Access Compliance Report

Public Rights-of-Way

(Curb Ramps)

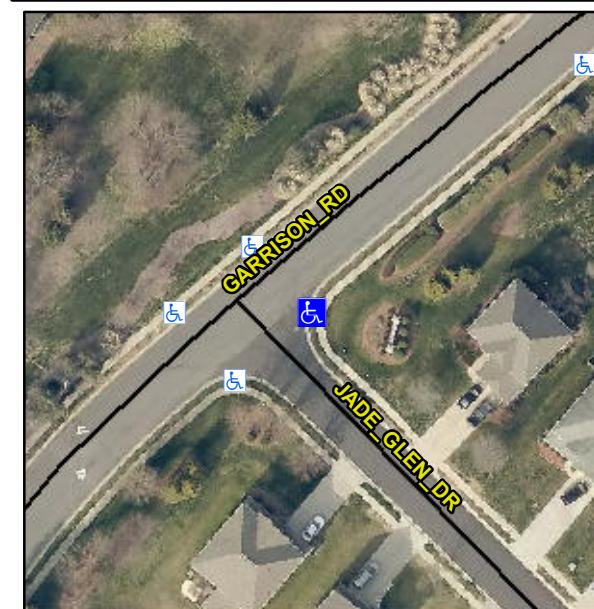
Intersection ID: 29183	Main Street: JADE_GLEN_DR	Cross Street: GARRISON_RD	Location: E
ADA ID: EB399DB659A1	Ramp Type: PerpDiag	Initial Pass/Fail: Fail	Overall Compliance: No
Severity Score: 8.75			
Codes/Mitigation Info/Possible Solution		Field Measurements/Component Compliance

Compliance	Description	Data	Compliance	Description	Data
N/A	Ramp Length (in)	49.0	Yes	Ramp Slope (%)	7.3
No	Ramp Width (in)	41.5	Yes	Ramp XSlope (%)	0.9
N/A	Flare Type LT	N/A	N/A	Flare Type RT	N/A
N/A	Flare Slope LT (%)	N/A	N/A	Flare Slope RT (%)	N/A
N/A	Flare Traversable LT?	N/A	N/A	Flare Traversable RT?	N/A
N/A	Landing Length (in)	N/A	N/A	DWS Provided?	N/A
N/A	Landing Width (in)	N/A	N/A	DWS Contrast?	N/A
N/A	Landing Slope (%)	N/A	N/A	DWS Length (in)	N/A
N/A	Landing X Slope (%)	N/A	N/A	DWS Full Width?	N/A
N/A	Landing Curb? (Y/N)	N/A	N/A	DWS Offset (in)	N/A
N/A	Shared Landing?	N/A			
N/A	Gutter Ponding?	N/A	N/A	Gutter Slope (%)	N/A
N/A	Gutter Lip Ht (in)	N/A	N/A	Gutter X Slope (%)	N/A
N/A	Painted X Walk1?	No	N/A	Painted X Walk2?	No
	X Walk 1 Direction	To NW		X Walk 2 Direction	To SW
N/A	X Walk 1 Width (in)	N/A	N/A	X Walk 2 Width (in)	N/A
	X Walk 1 Slope (%)	0.8		X Walk 2 Slope (%)	1.8
	X Walk 1 X Slope (%)	1.3		X Walk 2 X Slope (%)	0.9

Remove & Replace Curb Ramp With Two New Directional Ramps or Equivalent.
